STATE OF NORTH CAROLINA DEPARTMENT OF TRANSPORTATION

August 8, 2014

- Subject: Permit Modification Request for Section 10 and a Section 404 Nationwide Permit No. 23, Section 401 Water Quality Certification and Neuse River Riparian Buffer Authorization for the proposed replacement of TIP No. B-4565; Federal Aid Project No. BRSTP-70B(5); Debit \$240 from WBS No. 33773.1.1
- References: Section 10 and a Section 404 Nationwide Permit No. 23, Section 401 Water Quality Certification and Neuse River Riparian Buffer Authorization Application dated June 11, 2014;

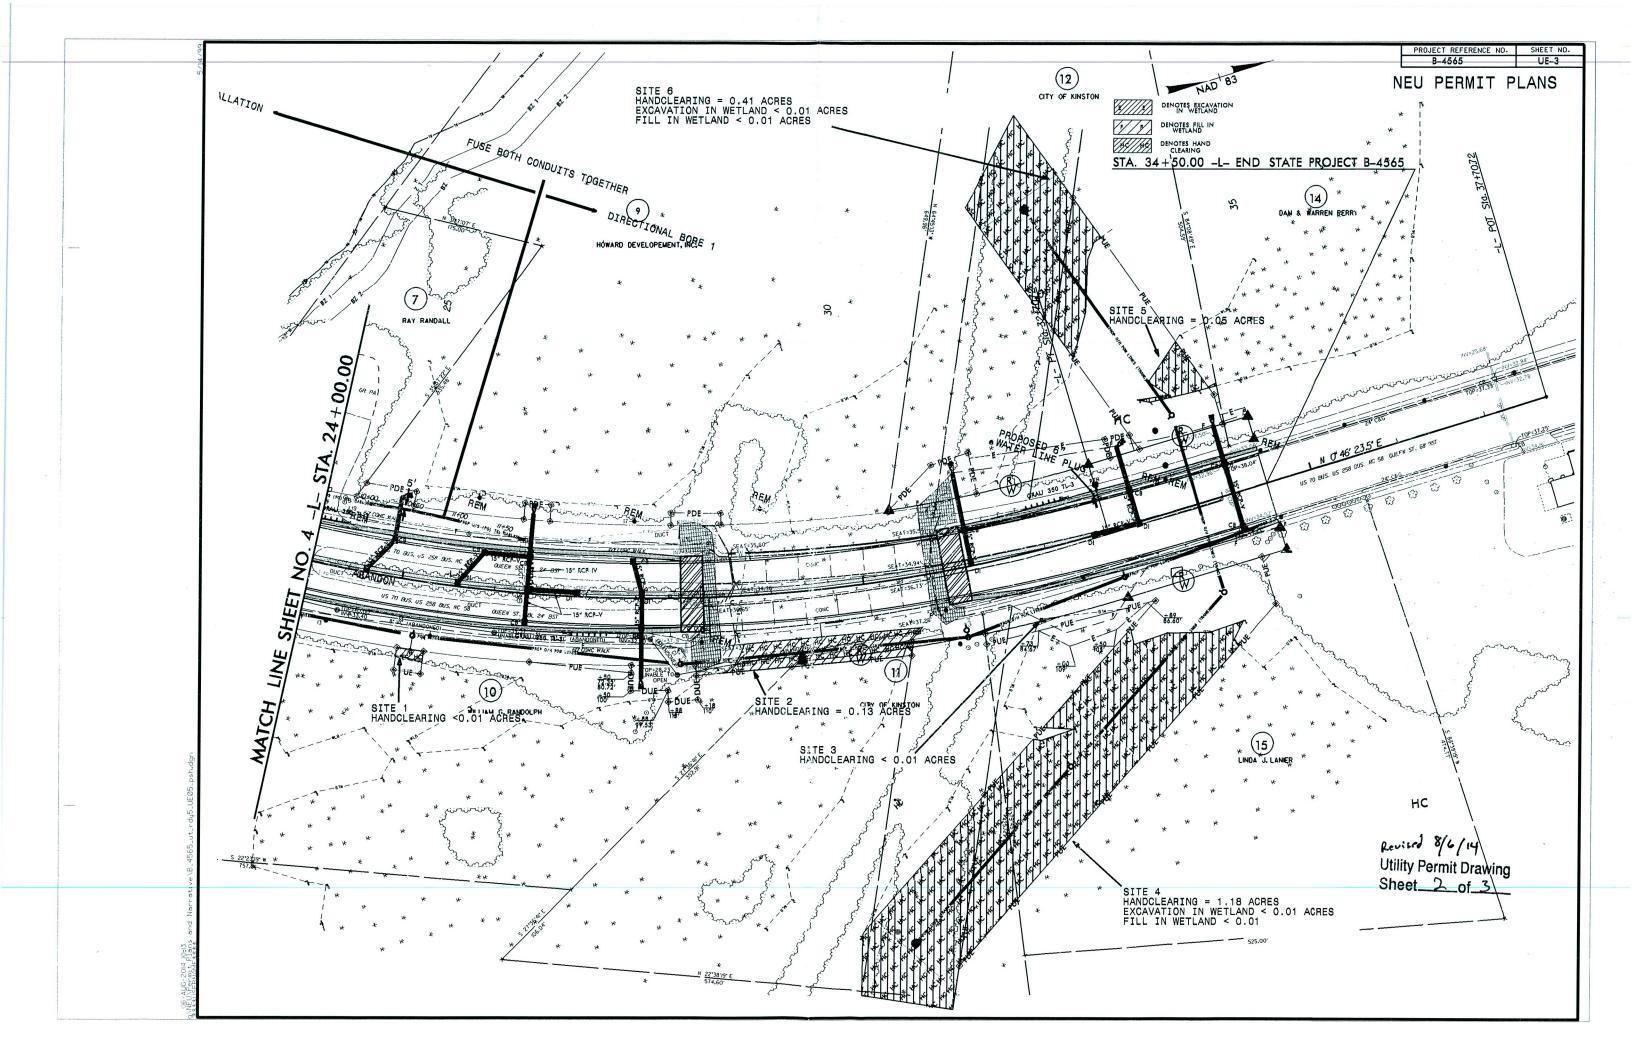
Please see the enclosed revised utility permit drawings for the subject project. Due to the utility contractor's need for additional room to relocate the power lines, mechanized clearing will increase hand clearing by 0.27 acre. This additional 0.27 acre increases the hand clearing due to utility relocation on this project to 1.79 acres.
